100BASE-T1L PCS and PMA Clause 45 Registers

Brian Murray
Philip Curran
Jacob Riesco

- ▶ This presentation discusses the new PCS and PMA clause 45 registers required for 100BASE-T1L

Figure 146–14—PMA Receive

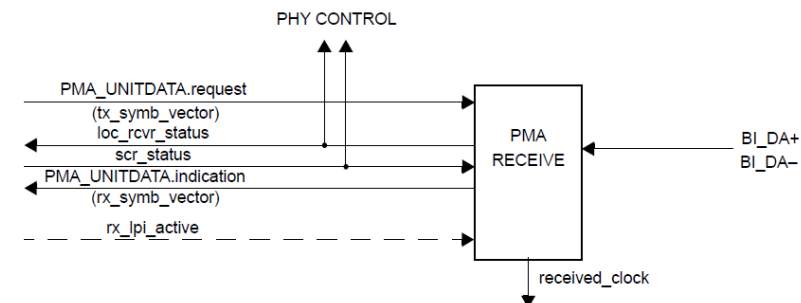
- **Add 100BASE-T1L row to Table 45-10**
 - 100BASE-T1L : 199.4.3

The PMA Receive fault function is optional. The PMA Receive fault function is the logical OR of the condition link_status = FAIL and any implementation specific fault. If the MDIO interface is implemented, then this function shall contribute to the receive fault bit specified in 45.2.1.7.5 and 45.2.1.XXXX.7.
